# International Isotopes Inc.

Subject: Submittal of Responses to Requests for Additional Information (RAI)  
TAC L32739.

The following documents are provided as a response to the US Nuclear Regulatory Commission RAIs pertaining to the International Isotopes Fluorine Products Inc. December 30, 2009 application to license a depleted uranium hexafluoride de-conversion and fluorine extraction process facility.

## Official Responses to Seismic and Structural RAIs

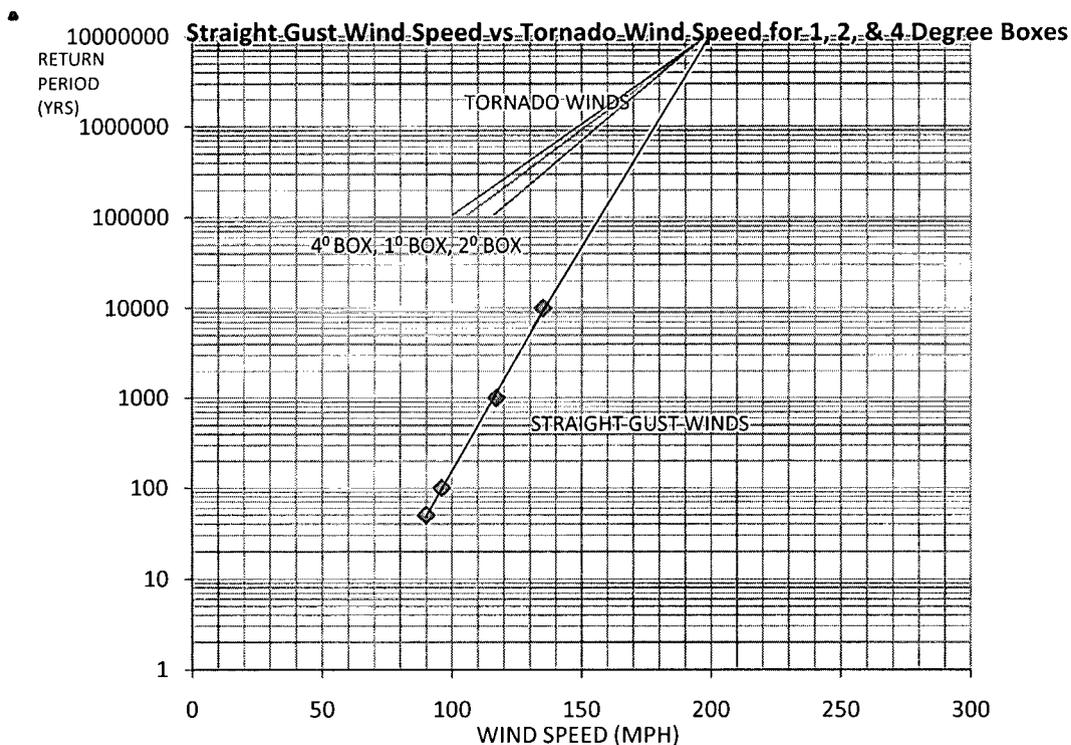
- 1. Characterize tornado and tornado-generated missile, straight wind, snow, rain, and flood hazards at an annual probability level (i.e., not unlikely, unlikely, or highly unlikely) consistent with their risk (i.e., low, intermediate, or high chemical or radiological consequence).*
- 2. Provide technical basis to justify the perceived risk level for each of the hazards identified in Item 1.*

The evaluation of tornadoes and straight winds was made based on NUREG/CR-4461, Revision 2 (February, 2007) including data in Appendices A, B and C of the NUREG. This NUREG guide provides calculations based upon 46,800 tornado segments occurring from January 1, 1950 through August 2003 of which more than 39,600 had sufficient information on location, intensity, length, and width to be used in the analysis included in this report. NUREG/CR-4461, Revision 1 had been published in April 2005. The National Weather Service changed from using the Fujita Scale to the Enhanced Fujita Scale in February 2007. Revision 2 incorporates the Enhanced Fujita Scale in its methodology and calculations. Specifically, Chapter 5 of the NUREG has been revised to show  $1 \times 10^{-5}$ ,  $1 \times 10^{-6}$ , and  $1 \times 10^{-7}$  probability design wind speeds (i.e., probability of

The two-degree box where the IIFP site is located is in Region 2. While the two-degree and four-degree boxes are considered to be more reliable since they contain data for more events, the document does allow the use of the one-degree data if the number of events is large enough to provide accurate calculations. Instructions for using the NUREG Appendix C, Results for one-degree boxes state that the data set should contain a minimum of 10 events with 20 or more events being desirable. There were 76 events reported for the one degree box whose SE corner is the 32°/103° gridline. Of these, 56 were used in the calculations. The four-degree box uses data from 364 events of the 435 events observed.

The data from the above NUREG appendices for the one-degree, two-degree, and four-degree boxes are used. The maximum tornado wind speeds versus return period for each box are plotted on the same chart with the straight gust wind speed data (DOE-1020-2002, Table 3-2) versus return period for sites with basic gust wind speed of 90 mph (per USGS maps as adopted by the model building codes). All three tornado wind speed curves intersect the straight gust wind speed curve at approximately a  $1 \times 10^7$  year return period or a probability of exceeding of  $1 \times 10^{-7}$ . DOE-STD-1022-2002, Appendix D, Paragraph D.2 states that, generally, straight and hurricane winds control the criteria for probabilities down to about  $10^{-4}$ . Therefore, straight gust wind speeds will be used as the wind design basis for building design at the IIFP Facility.
